ARAPAHO ROAD - PHASE III

SURVEYOR BOULEVARD TO ADDISON ROAD

PAVING PLAN AND PROFILE
STA 80+00 TO STA 85+00

TOWN OF ADDISON, TEXAS

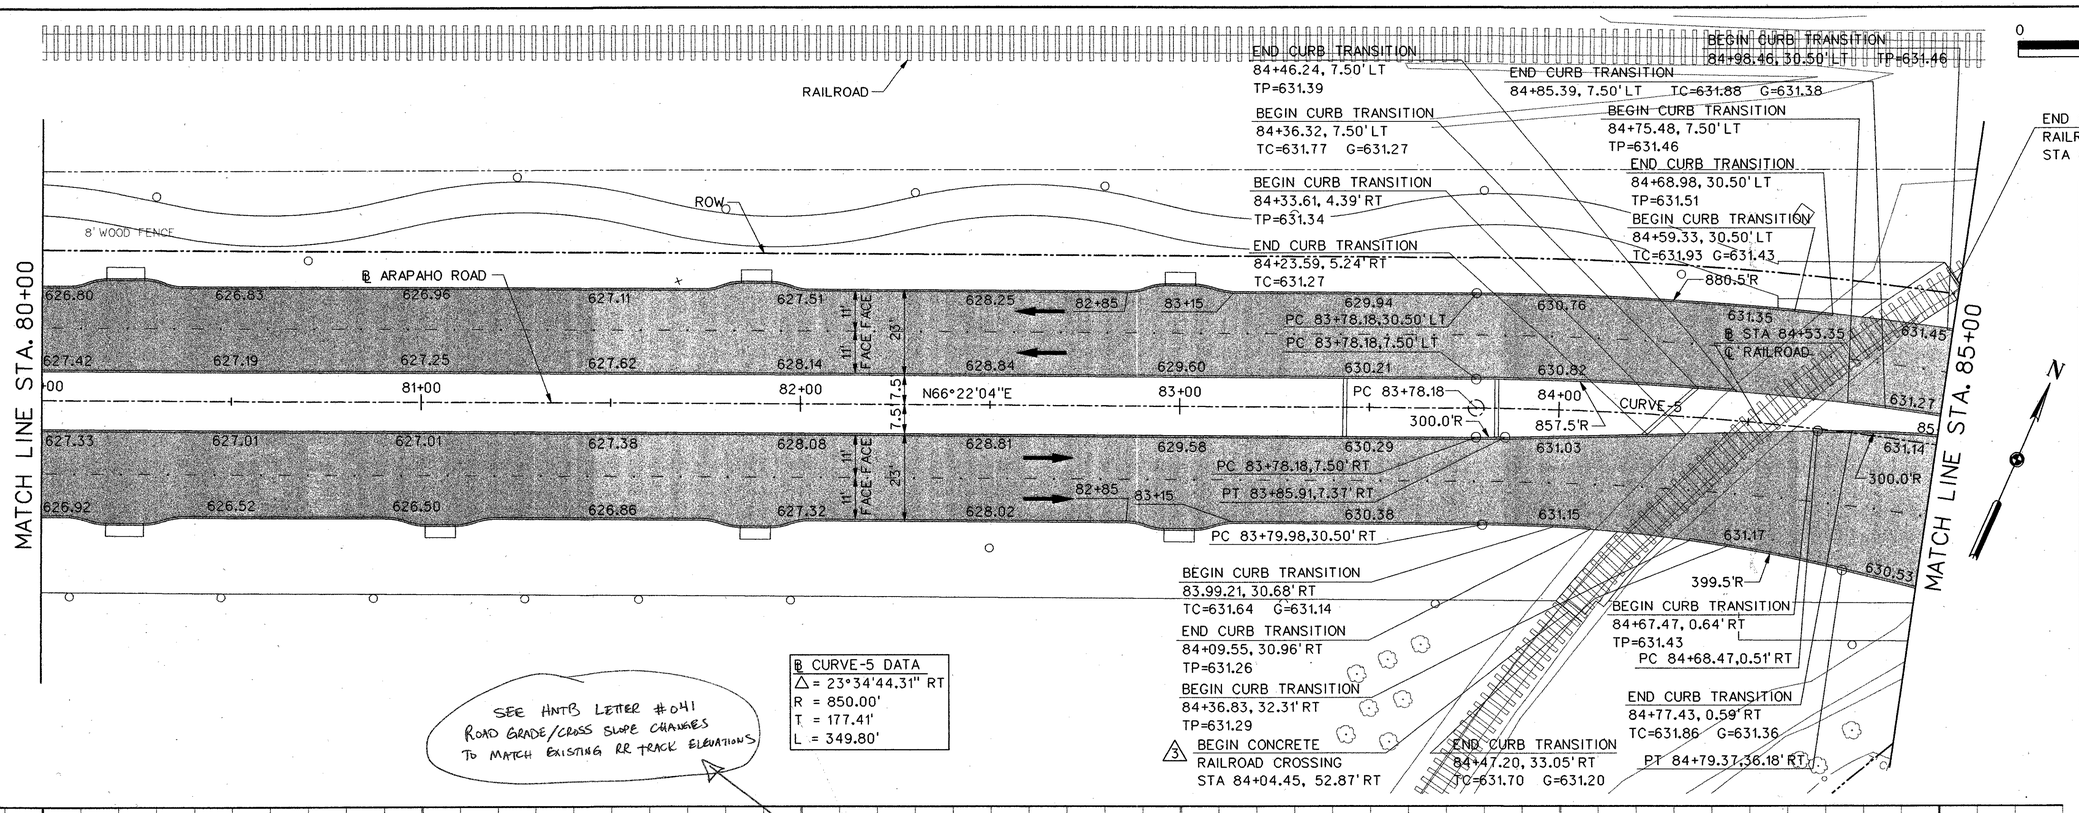
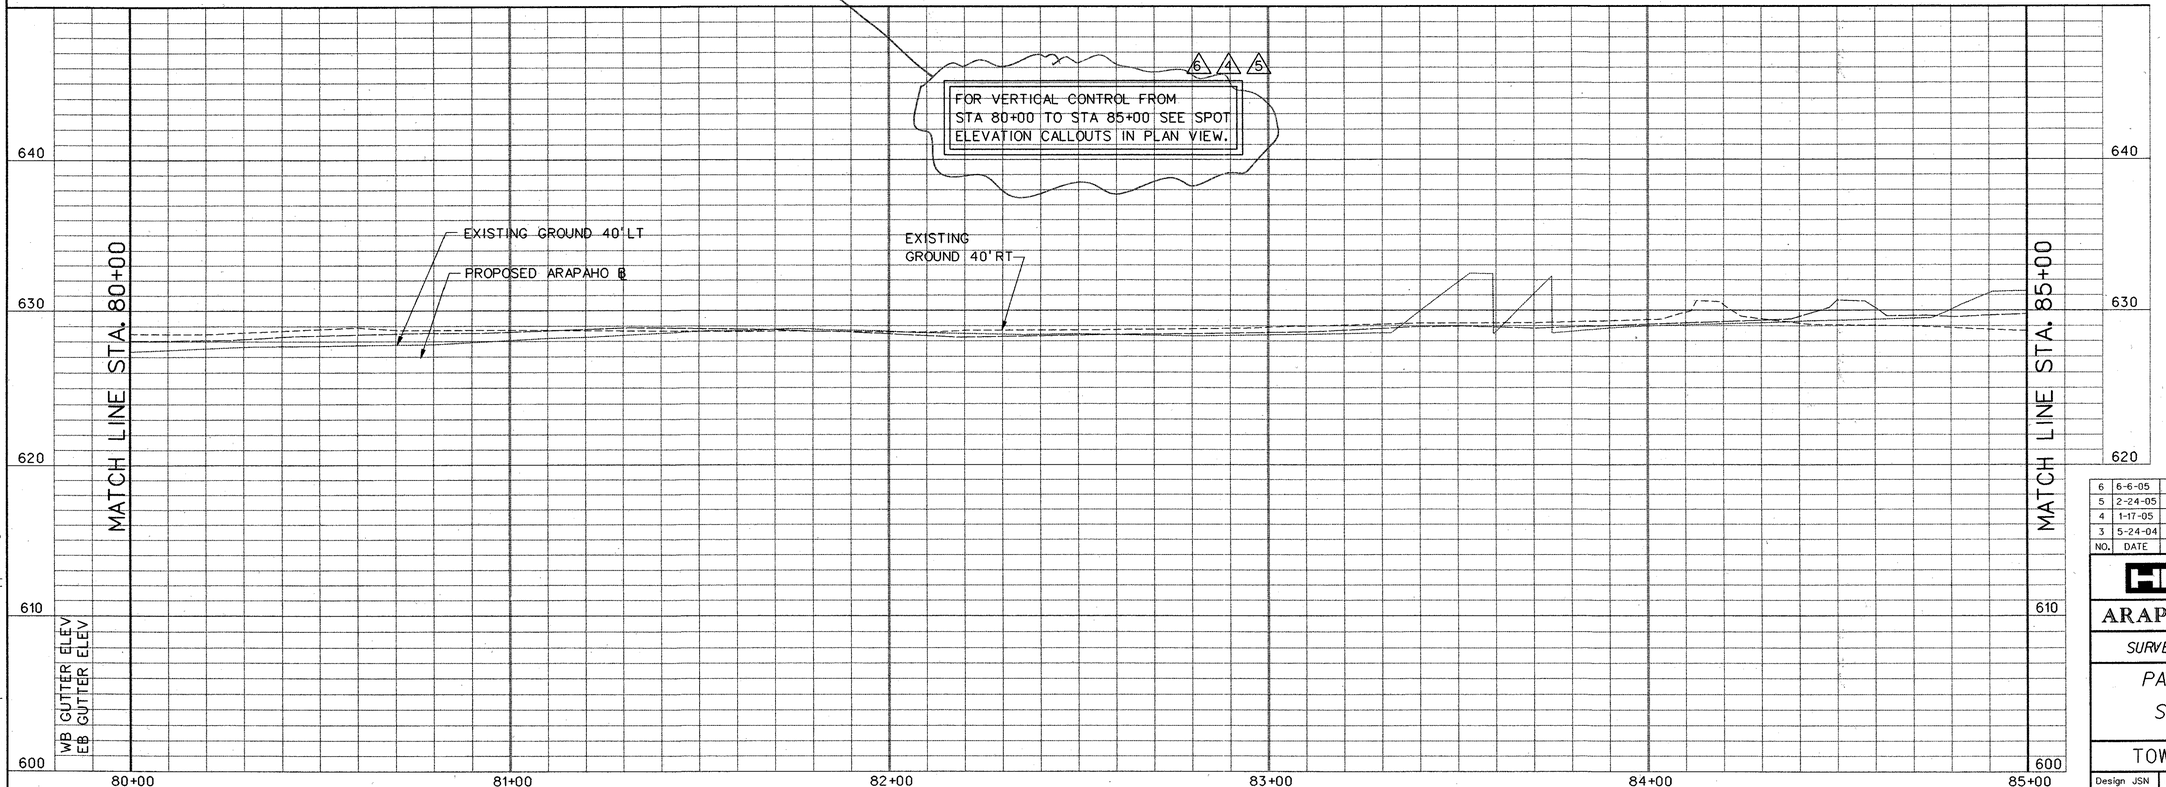
SEE HNTB LETTER #041
ROAD GRADE/CROSS SLOPE CHANGES
TO MATCH EXISTING RR TRACK ELEVATIONS

6 4 5
FOR VERTICAL CONTROL FROM STA 80+00 TO STA 85+00 SEE SPOT ELEVATION CALLOUTS IN PLAN VIEW.

NO.	DATE	REVISION	APPROV.
6	6-6-05	REVISED GUTTER SPOT ELEVATIONS	JDH
5	2-24-05	REVISED GUTTER SPOT ELEVATIONS	WSF
4	1-17-05	REVISED GUTTER SPOT ELEVATIONS	JDH
3	5-24-04	ADDED NOTES	JSN
